AGENDA (Final)

FLORIDA GREENBOOK ADVISORY COMMITTEE MEETING

Thursday, February 16, 2017, 8:30 AM – 5:00 PM

9:30 – 10:00 Presentation of Proposed Revisions for 2018 Greenbook

Figure 4 – 1 Clear Zone Plan View

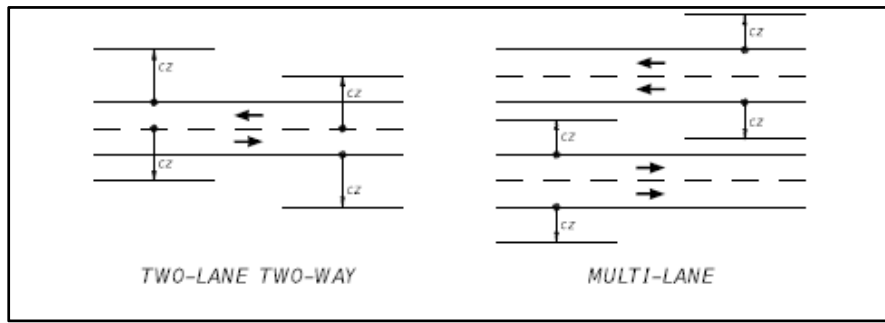
- Clarification of Figure 4 – 1 Clear Zone Plan View to better define where measurements are based on and also when to consider end treatments for opposing traffic.
- If there needs to be further guidance on the design of sidewalks at driveways and turnouts.
- Whether clarification is needed for the design of blended transitions at median refuge islands.
